Broken Hill Solar Plant

SUBMISSIONS AND PREFERRED PROJECT REPORT

February 2013

Figure 2-1 Indicative project layout and distribution of vegetation types (subject to detailed design)

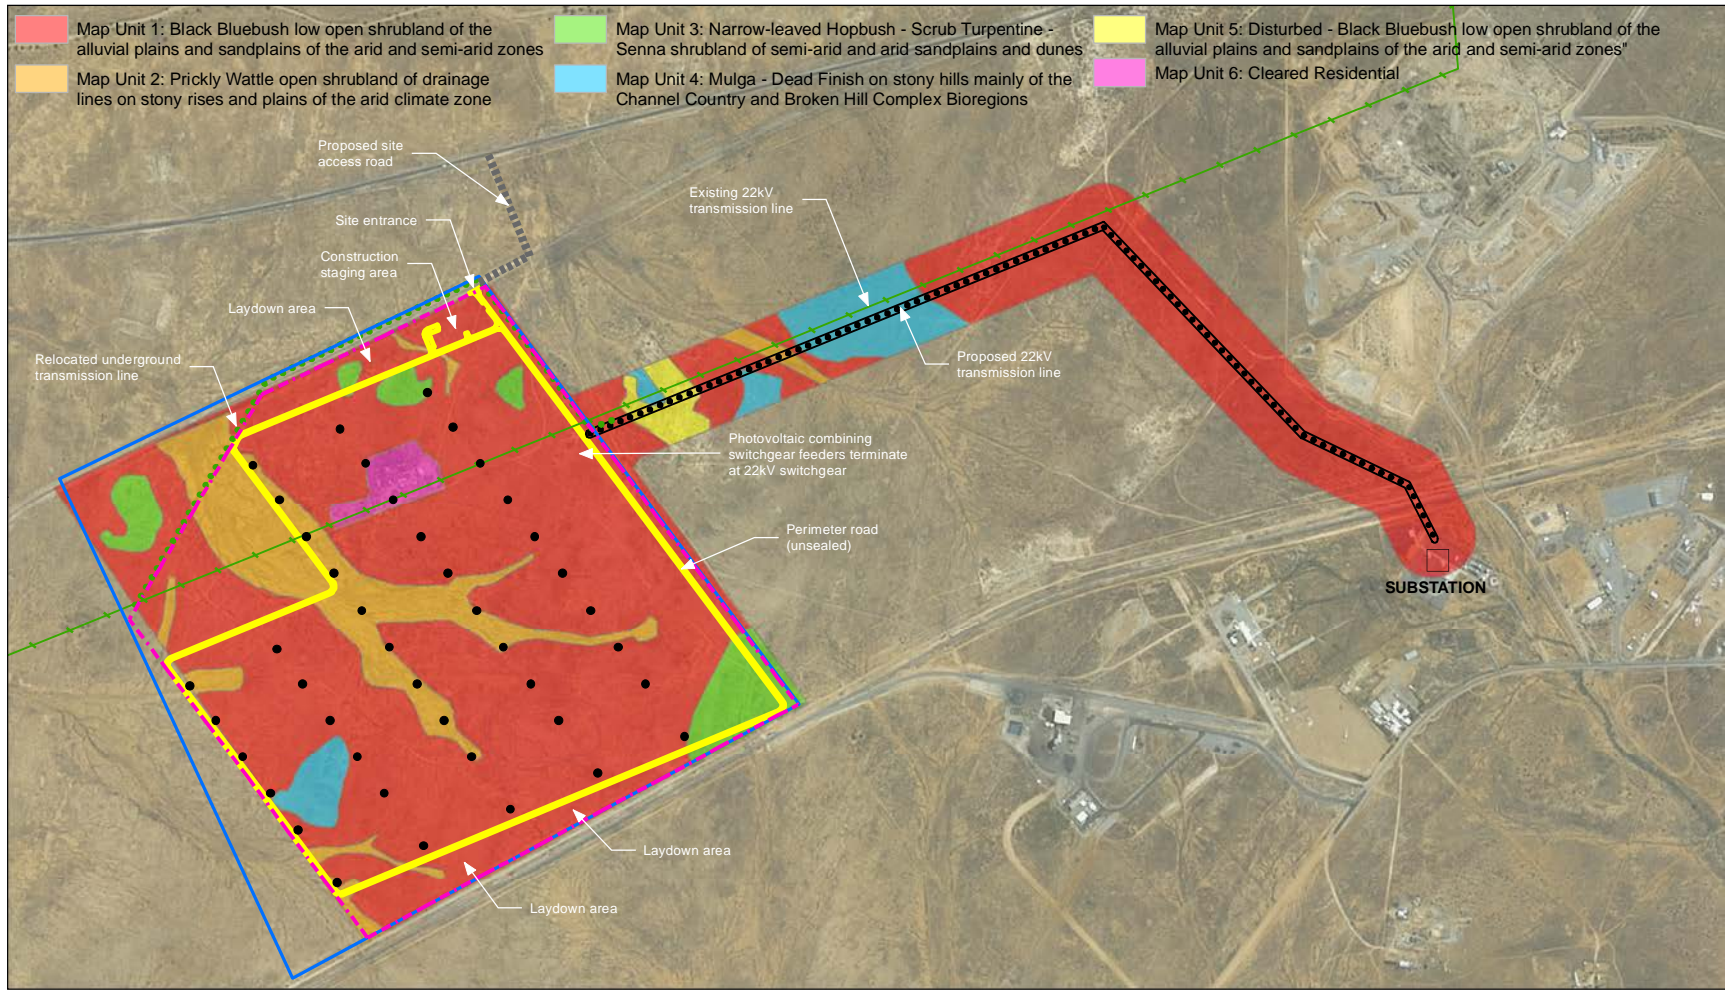
SUBMISSION: OEH seek clarification about a discrepancy between the map units identified in the body of the Environmental Assessment (EA) (Table 7-2) and the map units displayed in Figure 7-3.

RESPONSE: Figure 7-3 presented in the EA has been updated as Figure 2-1 in this report. Figure 2-1 reflects the Vegetation Classification and Assessment (VCA) database map units, which are consistent with the map units described in the EA (refer to Table 7-2 of the EA).

Figure 2-1 also illustrates the proposed project layout and proposed construction work sites in relation to the spatial distribution of vegetation communities.

■ **Figure 2-2 – Proposed Conservation Area (blue outline).**

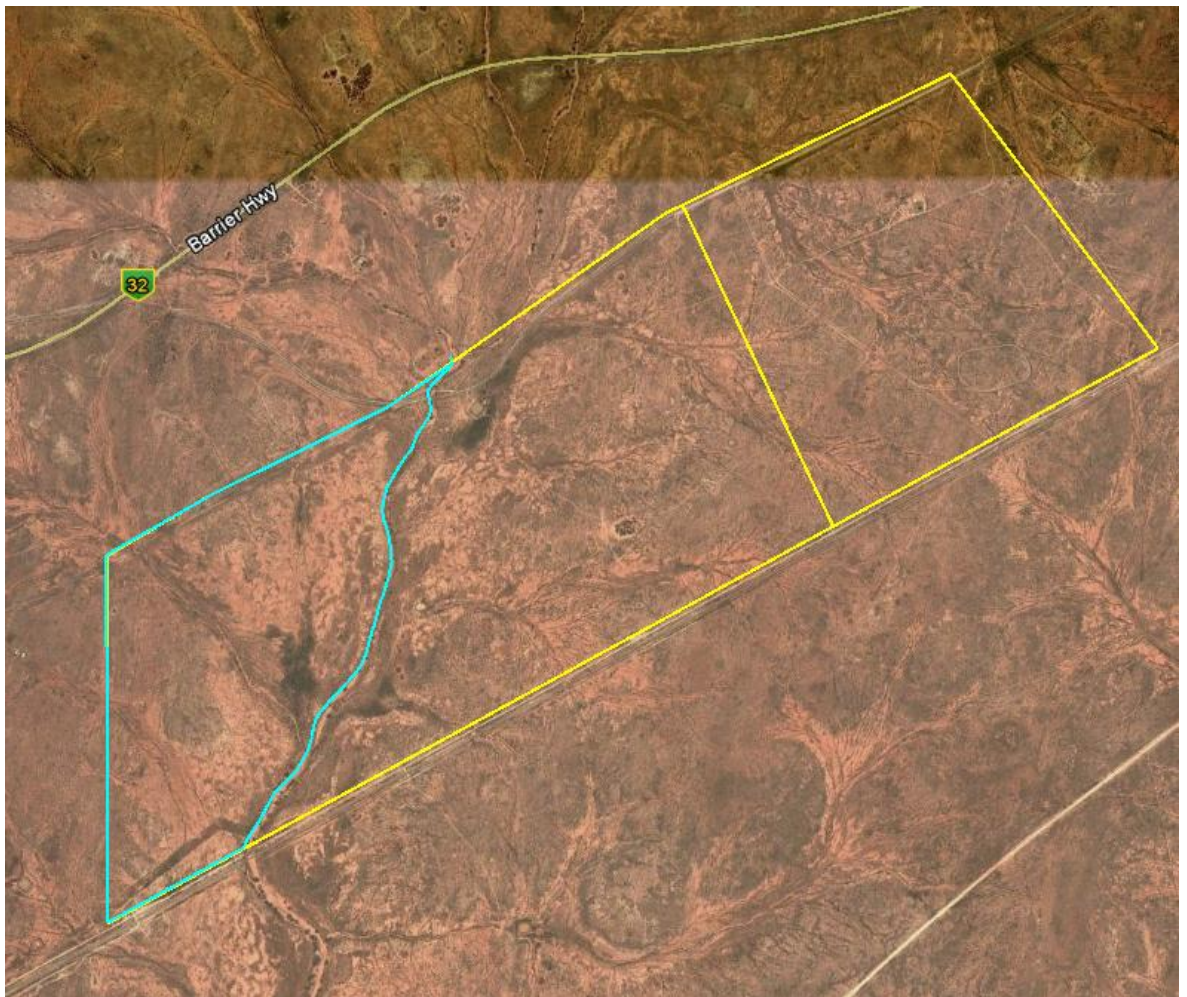
SUBMISSION: OEH supports the commitment in the EA to develop an Offset Strategy, in addition to the 60 hectares that is to remain undeveloped within the north west corner of the site. However, OEH feel that significant progress is required to ensure a viable offset is available before the proposal is operational.

RESPONSE: The Offset Management Strategy will be completed before clearing commences at the site. OEH will be consulted during the preparation of the Offset Strategy.

AGL has identified a suitable area of land on the property from which the proposed solar plant site will be subdivided. AGL has had discussions with the lessee of that property (Western Lands Lease (WLL) 14240). The area of the proposed Conservation Area located on the western portion of

WLL 14240 is identified by the blue outline in Figure 2-2. The lessee has agreed to the proposed establishment of a Conservation Area on that land.

■ **Figure 3-1 Indicative project layout (subject to detailed design)**

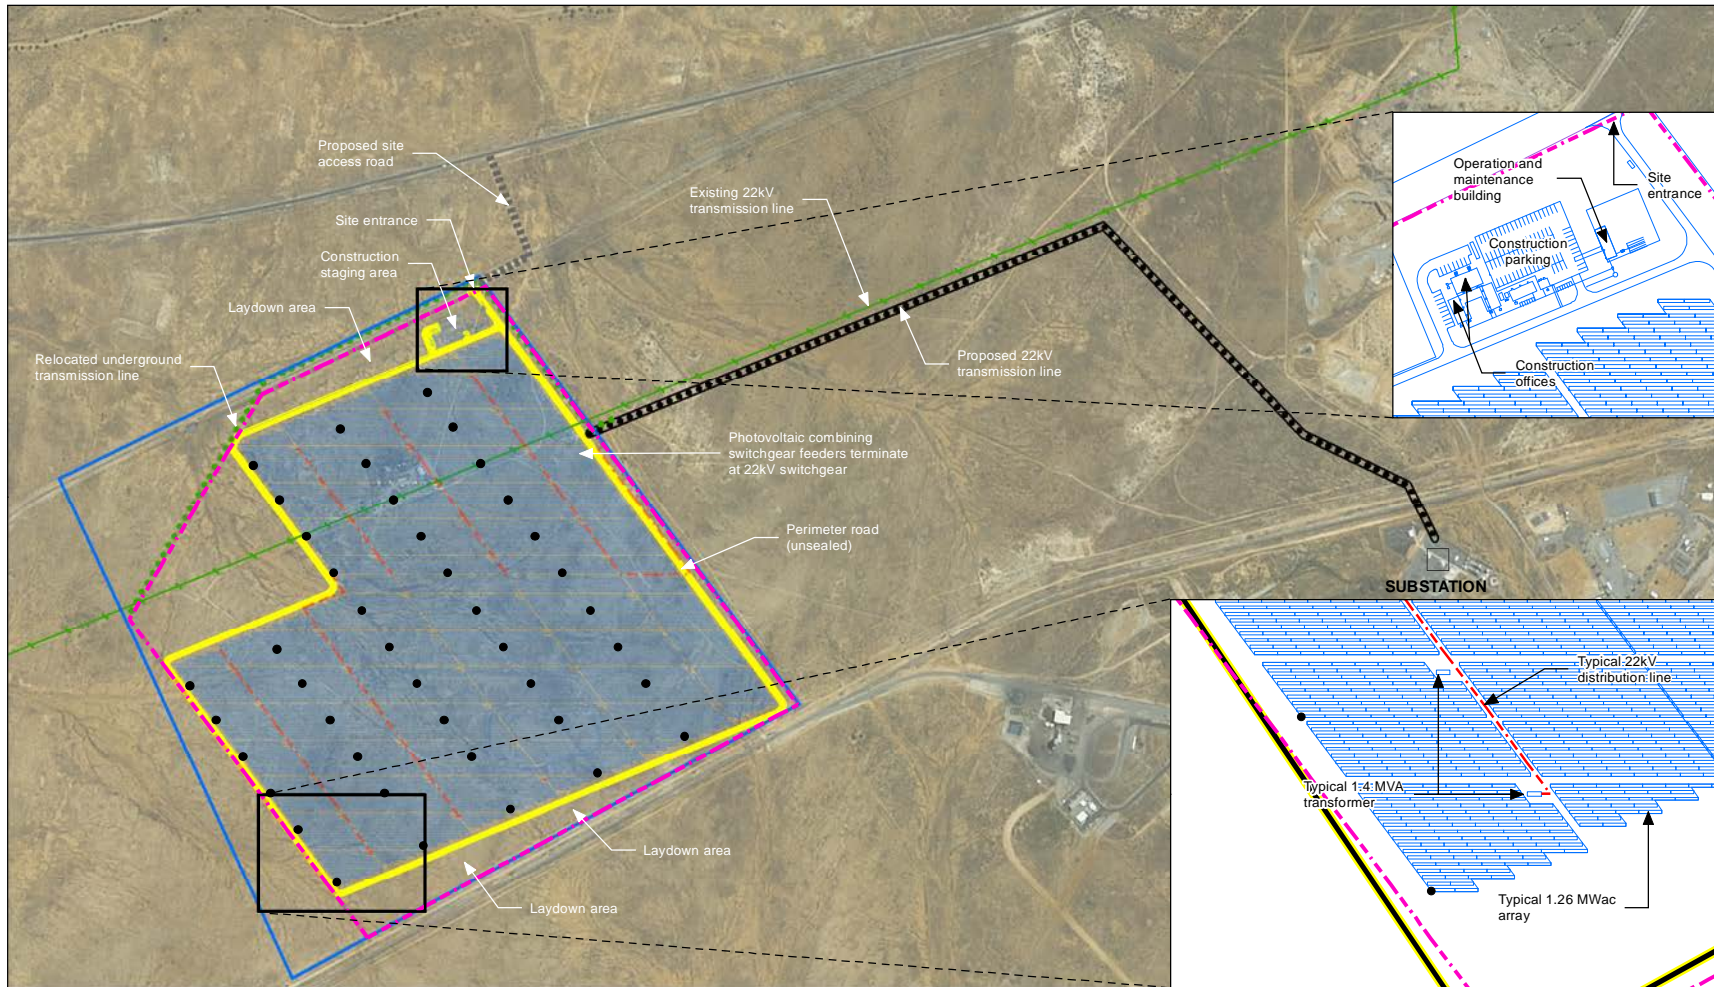
SUBMISSION: OEH seek clarification regarding the vegetation clearing estimates, as there is a discrepancy in the document. In addition, OEH seek clarification regarding whether temporary areas associated with the construction of the solar plant, and the location of these temporary areas to determine if they are likely to impact on the ongoing management of offsets that are identified as part of the approval conditions.

RESPONSE: The clearing estimates have been updated based on a revised site layout. This layout is illustrated in Figure 3-1. The revised vegetation clearing estimate is 140.4 ha. This is indicative and based on preliminary design. All proposed clearing will be assumed permanent. The following elements of the project were included in the vegetation clearing estimate:

Minor changes have been made to the proposed solar plant layout since the EA was exhibited in November 2012. These changes were made as part of ongoing engineering design and in an effort to reduce environmental impact. Changes to the plant layout include:

- The overall solar plant footprint has been reduced.
- The site entry and operation and maintenance building have been relocated to the east.
- A temporary laydown area will be established to the north of the solar arrays, and two smaller laydown areas will be located to the south of the arrays.

The revised plant layout is shown on Figure 3.1 and in Appendix C.
